SERVICE INFORMATION

Bulletin Nbr: 811-2100

Noise from the door window glide rollers

All Saab 9-3 Convertible M98 - M99 up to and incl. chassis no. X7057279.

51 13 436 Glide roller dark grey (4 pcs/car)

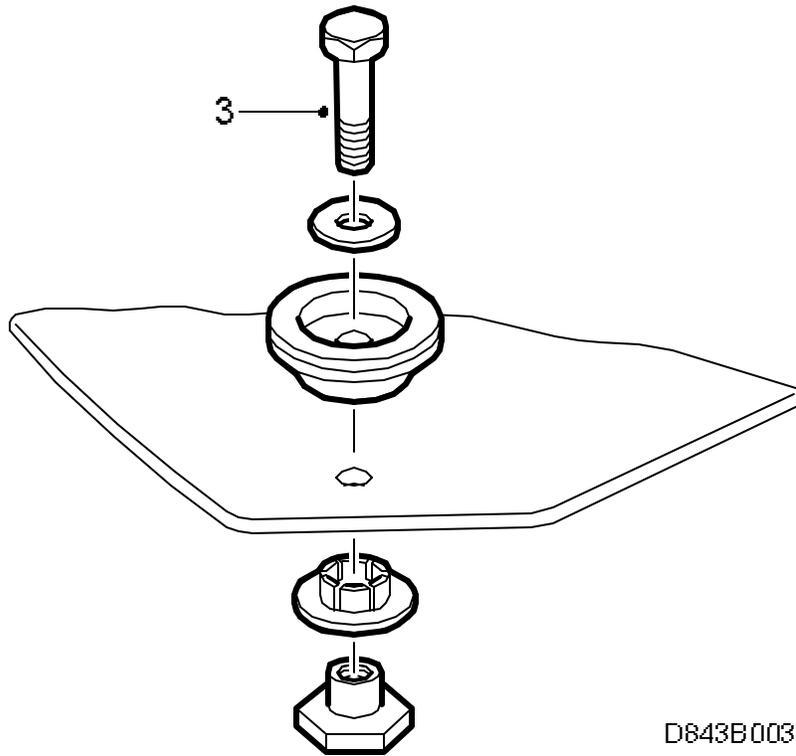
On certain cars, the friction in the glide rollers can cause high-frequency creaking noise. In case of customer complaints, change the glide rollers to new rollers with the following part number.

2. Lay the window glass on a soft and level surface.
3. Remove the glide rollers. Loosen the screw (hold the nut on the rear of the window). Remove the glide roller.
4. Fit the new glide rollers part no. 51 13 436. Tighten the screws.

Tightening torque : 9 Nm (6.7 lbf ft)
